**AMENDMENT TO THE
PRELIMINARY DRAINAGE REPORT
for
WINDERMERE**

Engineering Review

**EPC Planning & Community
Development Department**

**WINDERMERE
PRELIMINARY PLAN**
N. MARKSHEFFEL ROAD
EL PASO COUNTY, COLORADO

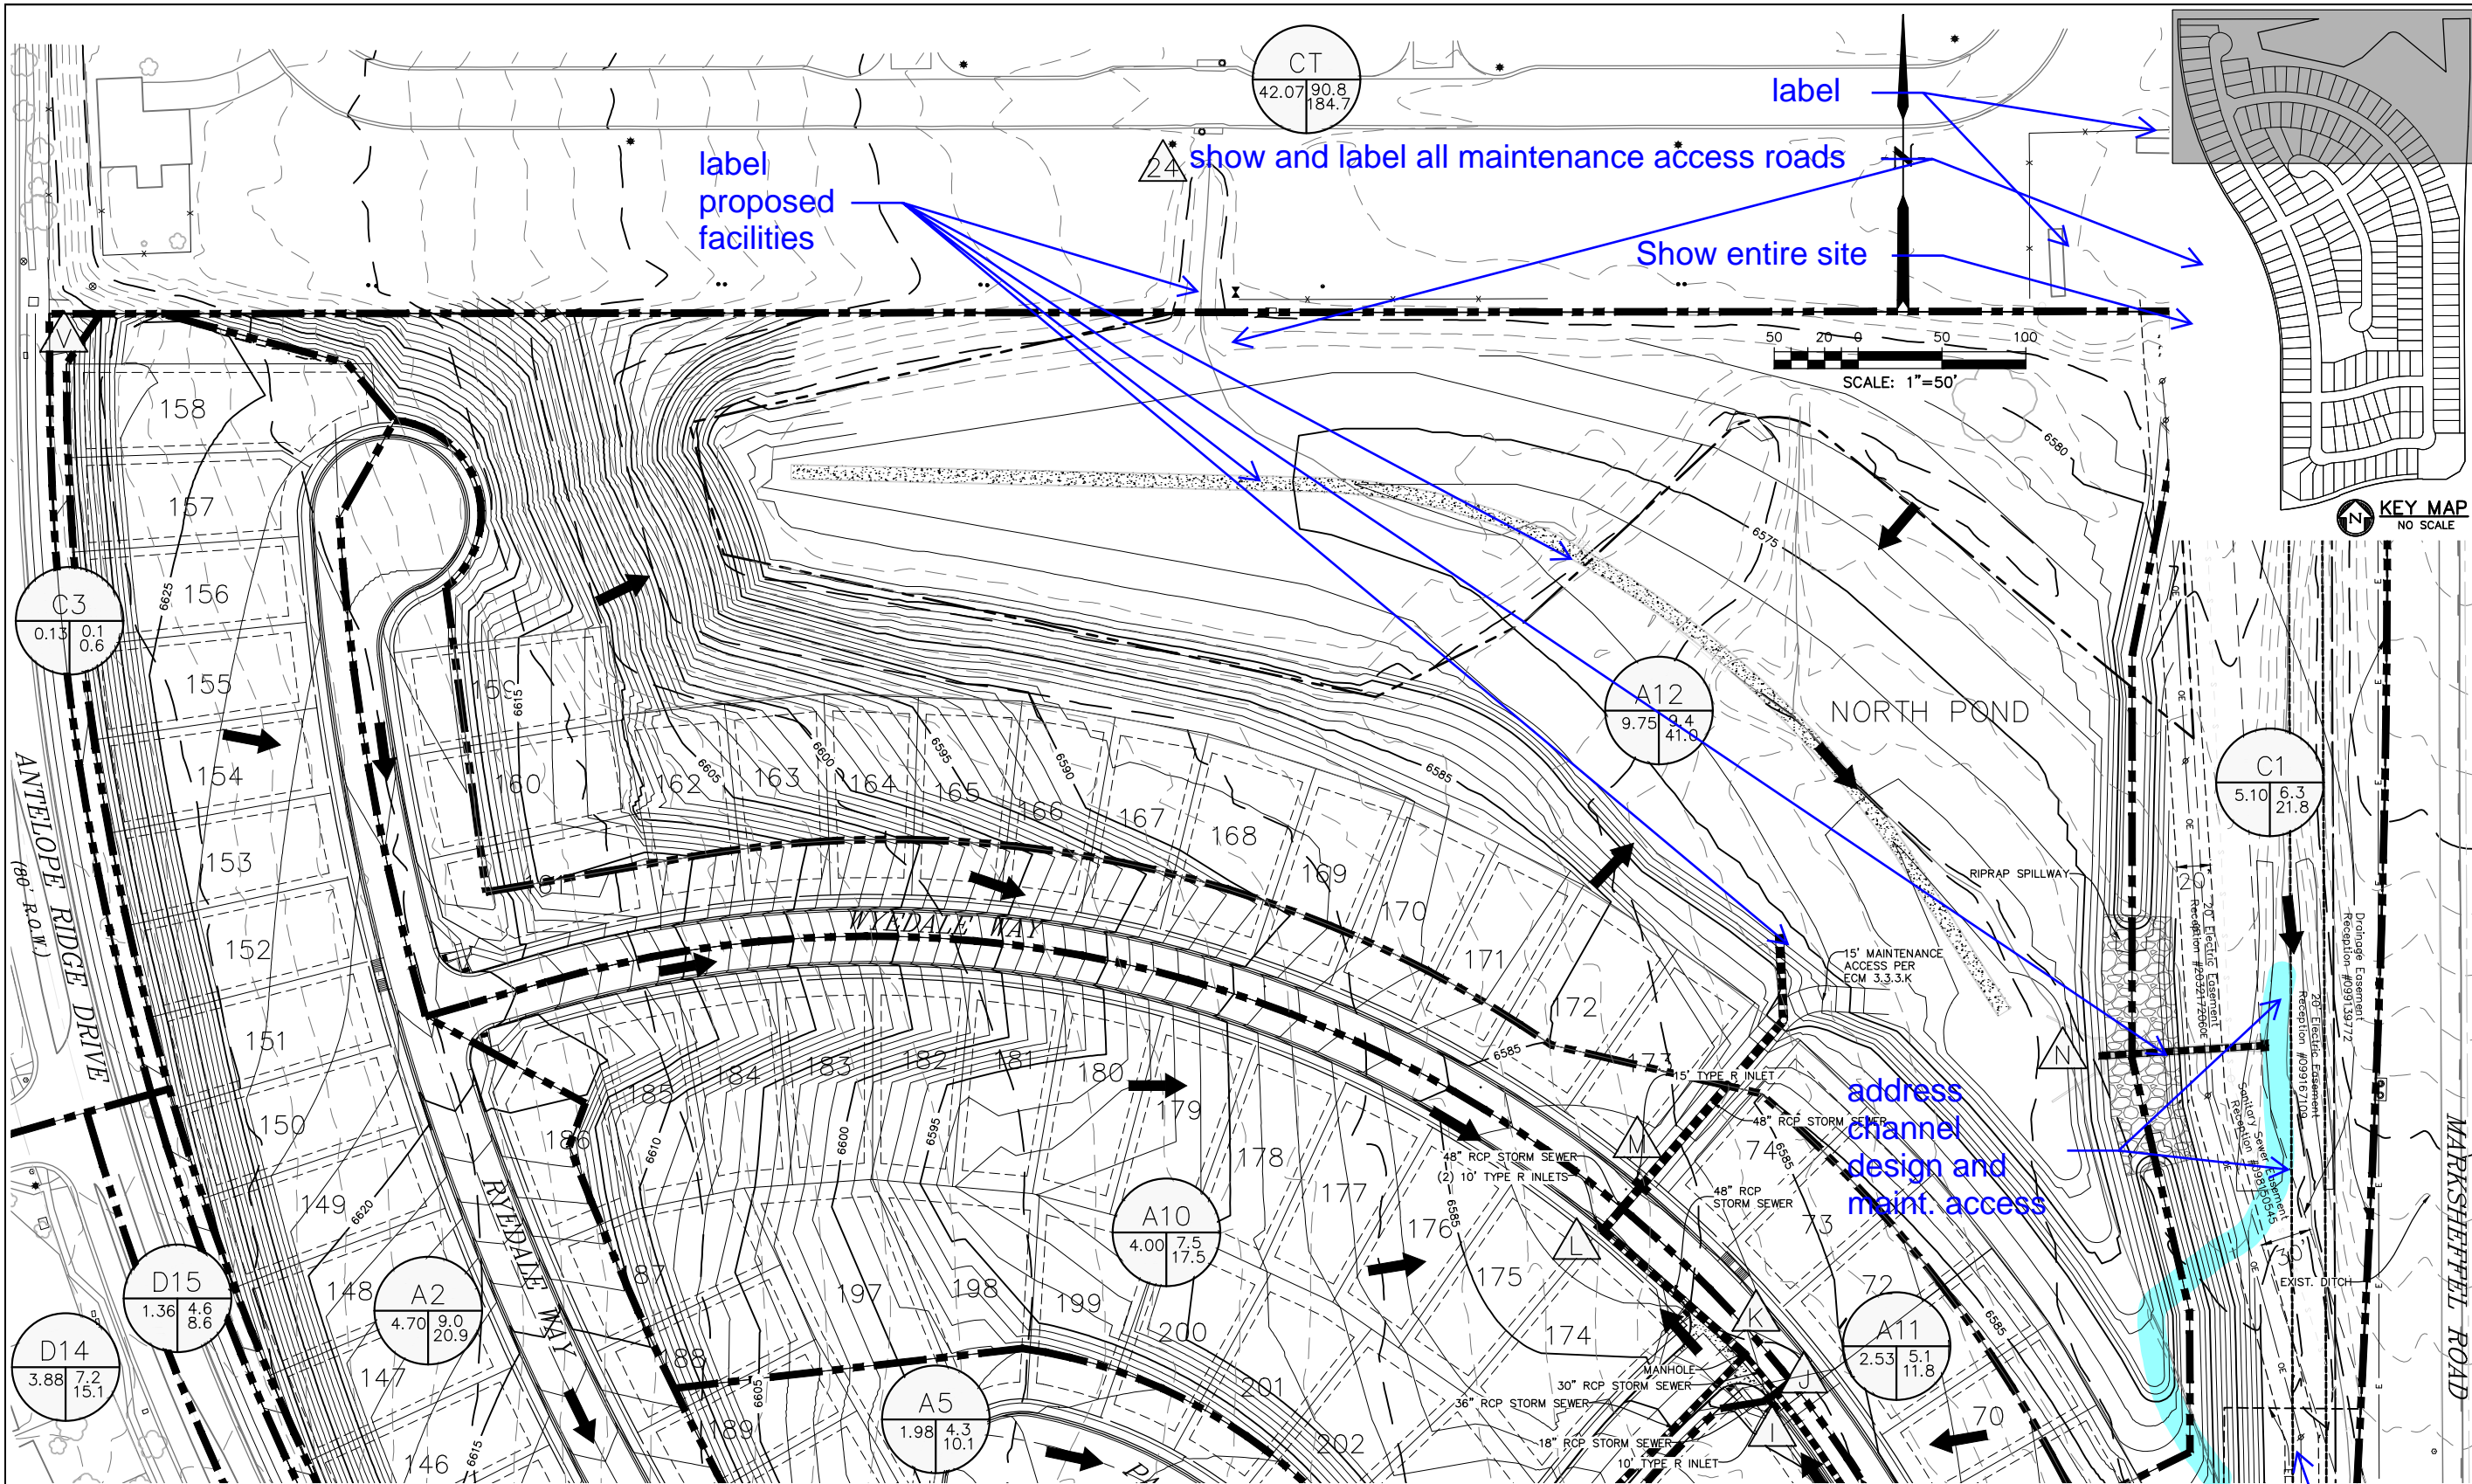
label
proposed
facilities

show and label all maintenance
access roads

Show entire site

show ROW
dedication

SHEET: 3 OF 3

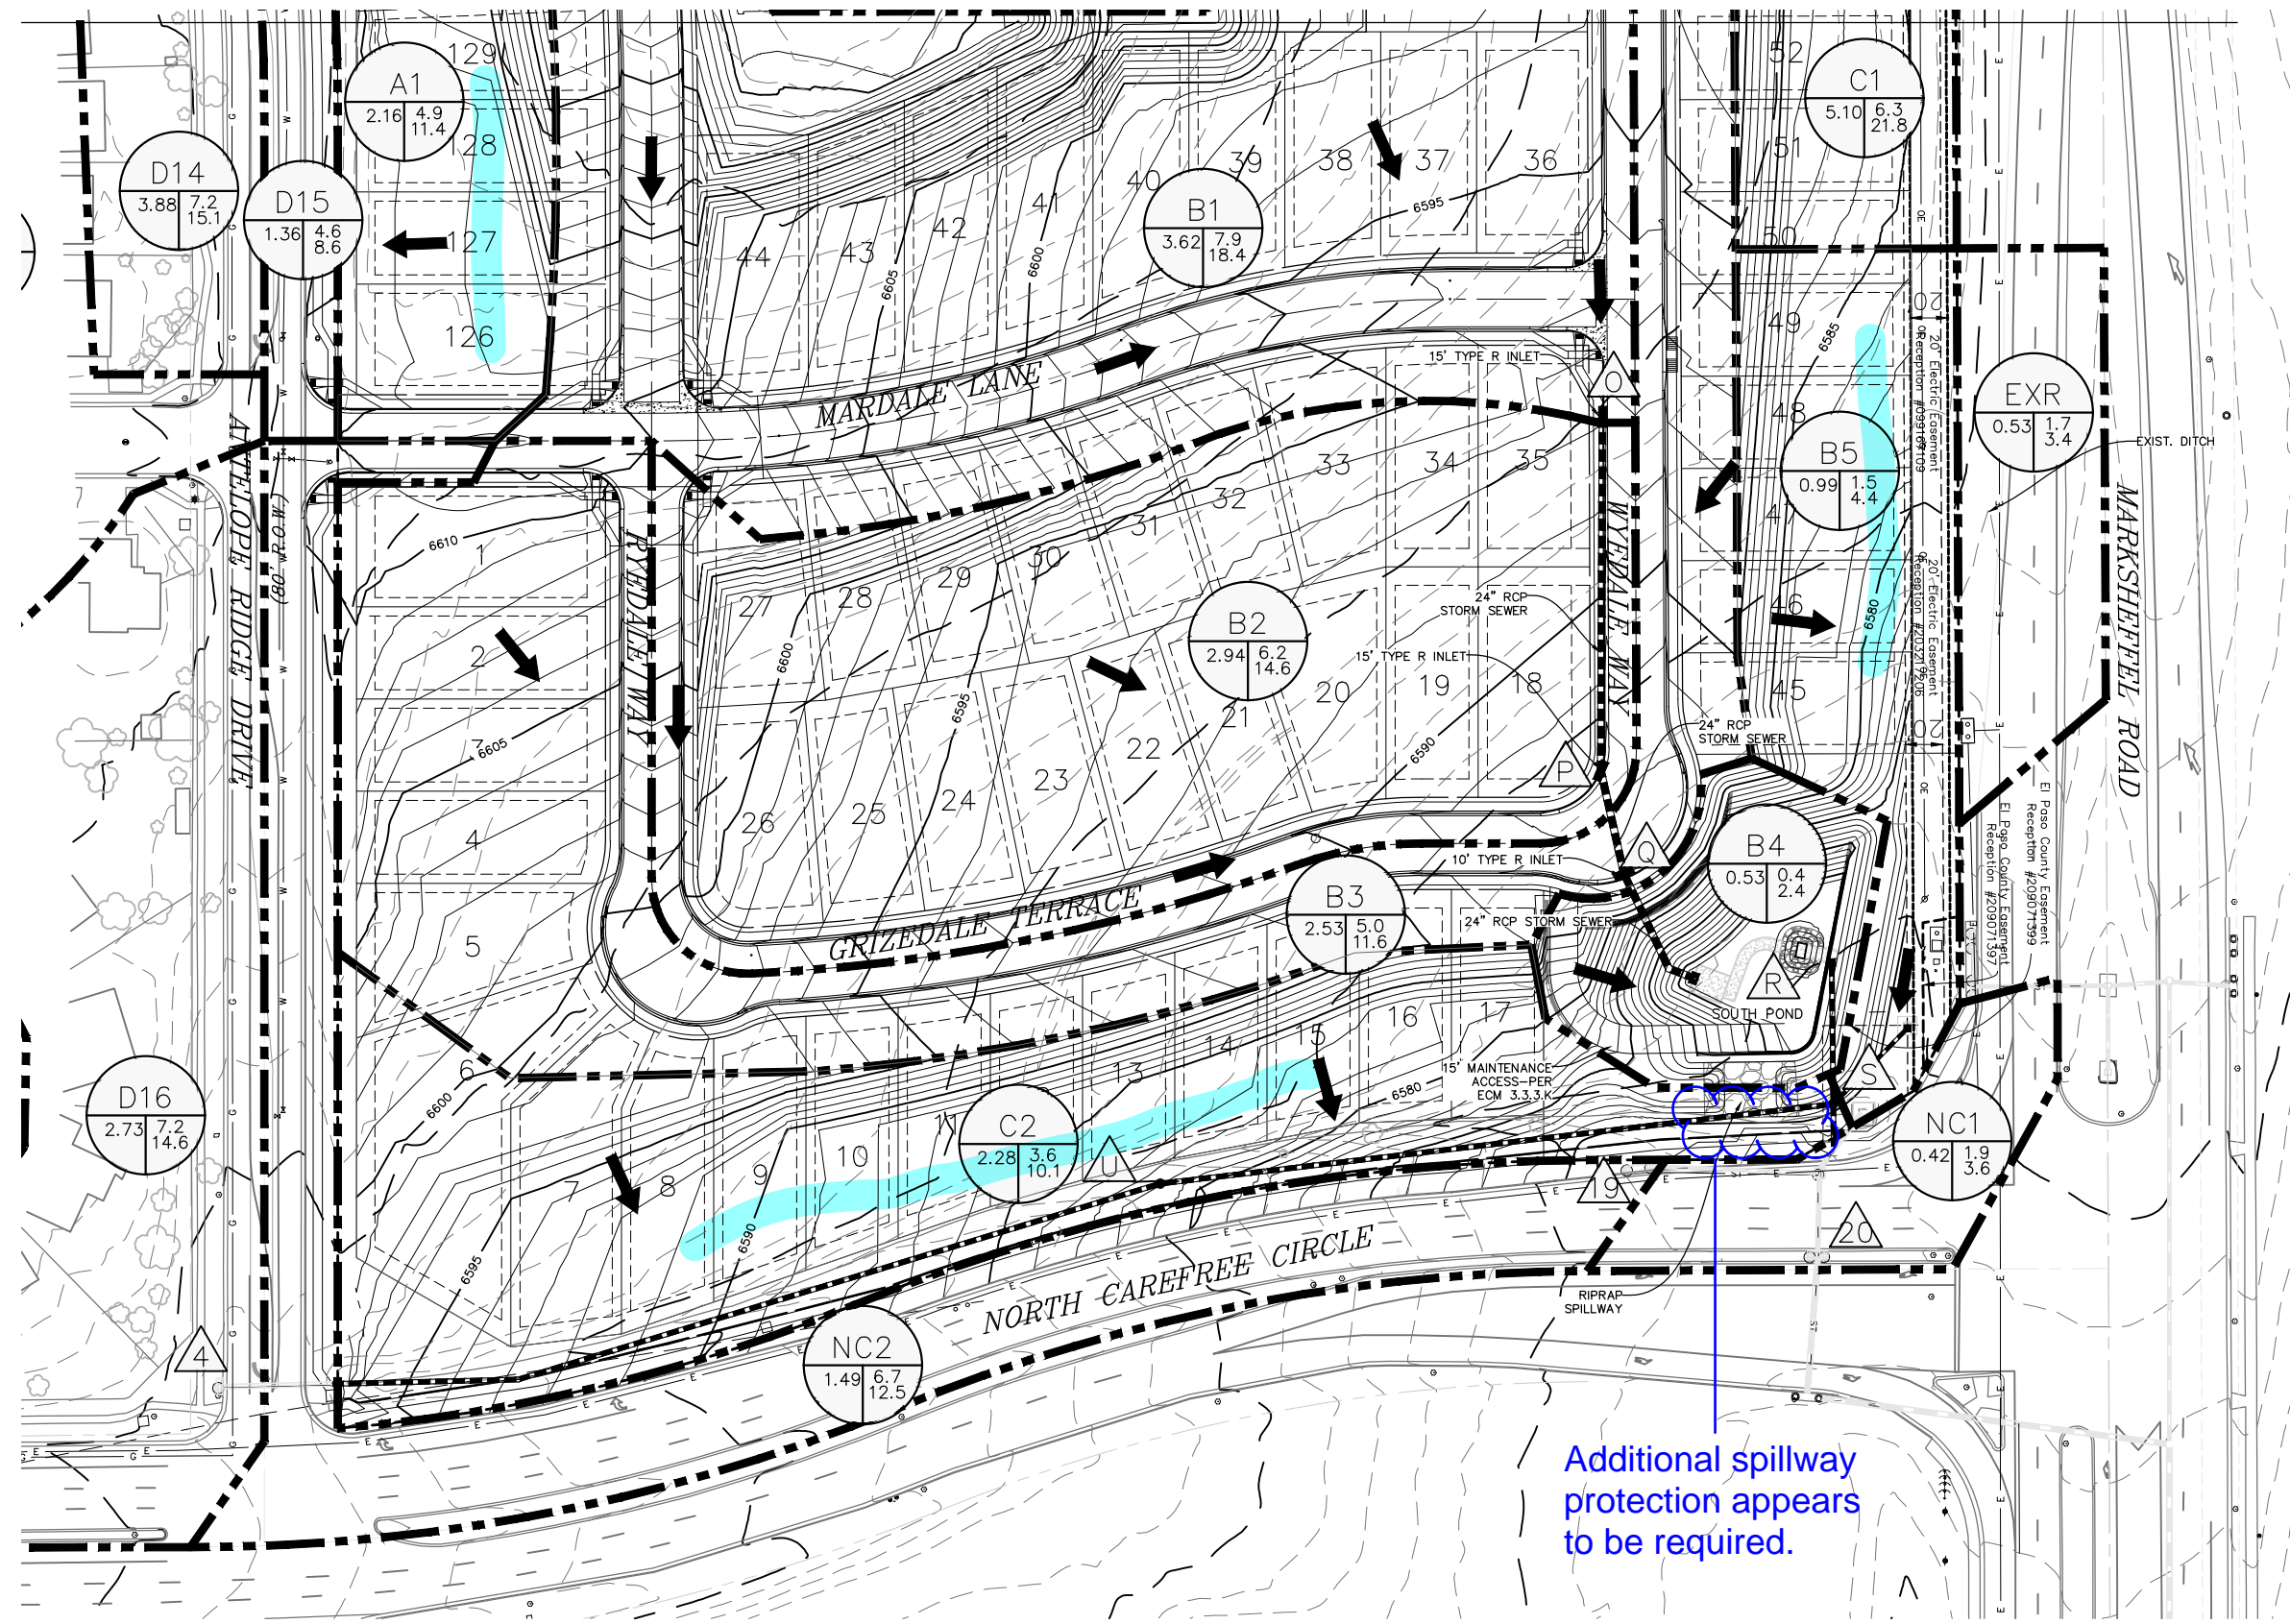
Provide all DPs
